SVE BULLETIN

QVM Bulletin Q-91

F-Series Super Duty With 6.0L Diesel Dual to Single Alternator Conversions

Models Affected: F-Series Super Duty (F-250/350/450/550) with 6.0L Diesel Engine

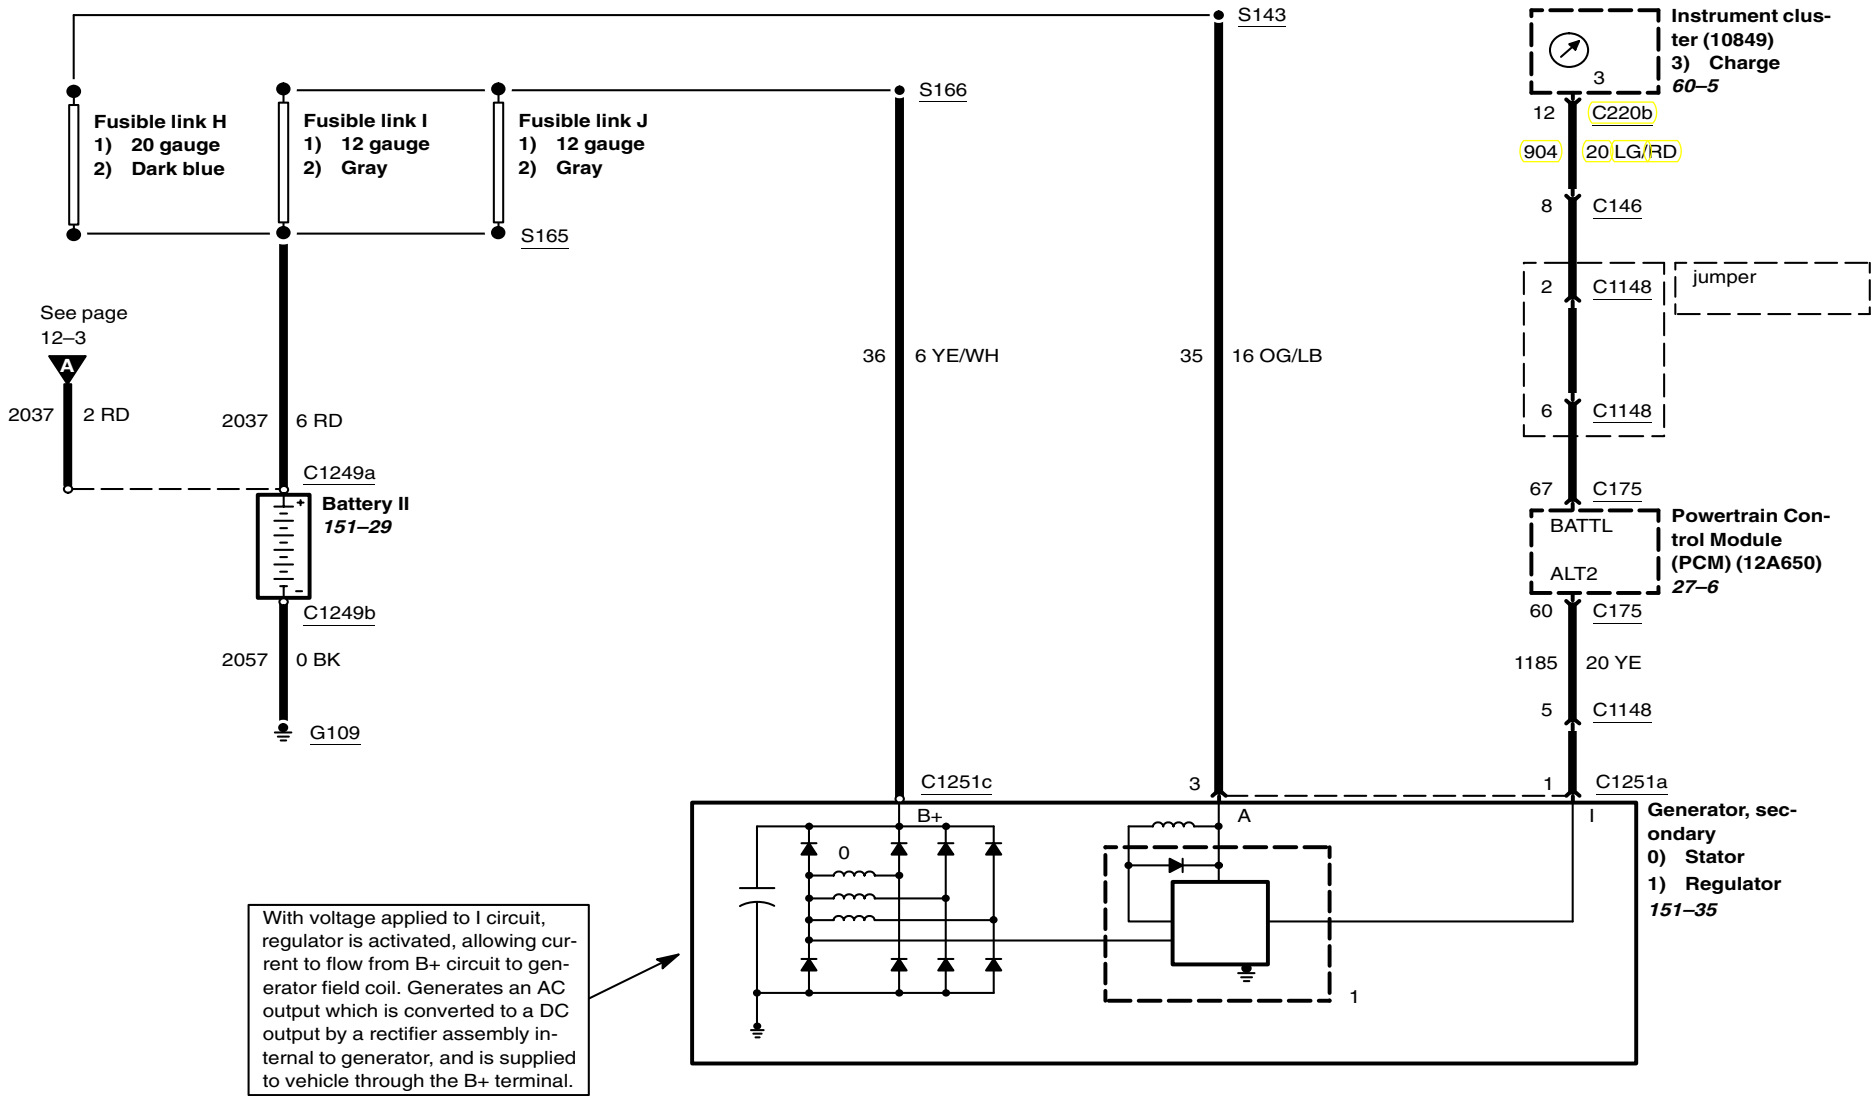
The 6.0L Diesel engine Powertrain Control Module (PCM) will randomly select only one of the alternators to be active when the glow plugs are active. There is no way to tell the PCM that one of the alternators has been removed, so the removed alternator may be selected by the PCM. The lack of a working alternator during glow plug activation would result in discharged batteries.

To eliminate the possibility of this occurring, the dual alternators wiring must be altered to take the PCM out of the circuit.

- 1) Disconnect the ground cables to the batteries.
- 2) Find Circuit 904 (LG/RD) at Pin 12 of the end connector (C220b) on the instrument cluster (Attachment #1). Cut this circuit leaving sufficient wire to connect to cluster section. The other section of the circuit will not be needed, but it should be shrink-wrapped to prevent damage to the PCM.

- 3) Connect the cluster side of circuit 904 (from Step #2) to any one of the unused pass-thru wires located near the parking brake pedal. Use 18-gauge wire.

- 4) Find Circuit 904 (LG/RD) at Pin 1 of the three-pin connector (C102a) on the primary alternator (Attachment #2). Cut this circuit leaving sufficient wire to connect to the alternator section. The other section of the circuit should be handled as the unused section in Step #1.

- 5) Connect the engine compartment side of the selected pass-thru wire (Step #3) to alternator section of circuit 904 (LG/RD) (Step #4). Use 18-gauge wire.

- 6) Remove the secondary alternator. Protect the wiring harness attached (3pin connector) and the power cable. The single alternator power cable may be purchased at your local Ford dealer.

- 7) Reconnect the ground cables to the batteries.
